MEMPHIS STATE UNIVERSITY  
MEMPHIS, TENNESSEE 38152

An application for Amendment No. 1 to Memphis State University Facility Operating License R-127, Docket 50-538 was transmitted to your office by letter dated August 3, 1979. It is requested that the following typographical errors and omissions be corrected in the original document in order to provide clarity and enhance the review process:

FIGURE II-6. PROPOSED AGN-201 SHIELD

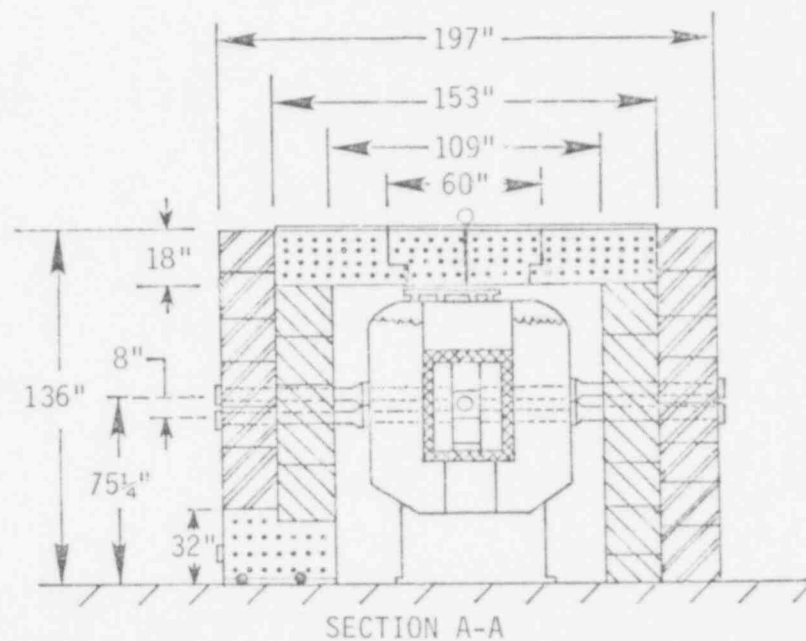
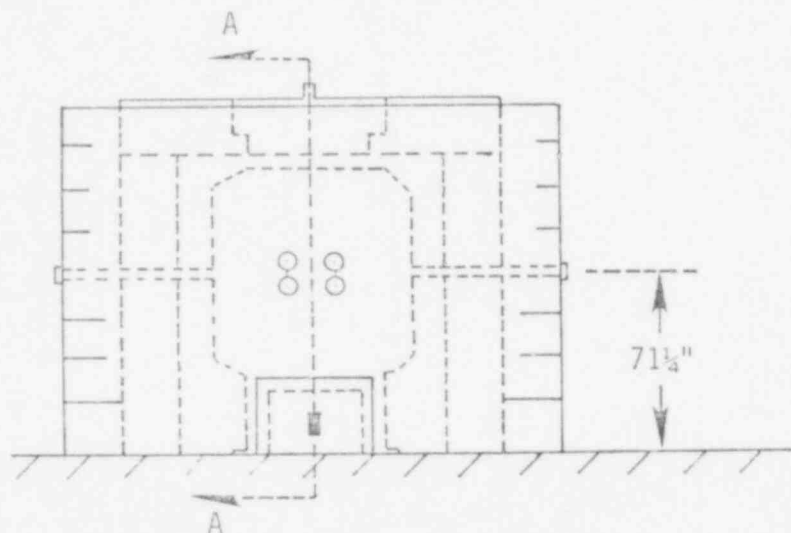
Page 13, Figure II-6: replace this page with the enclosed corrected page 13.
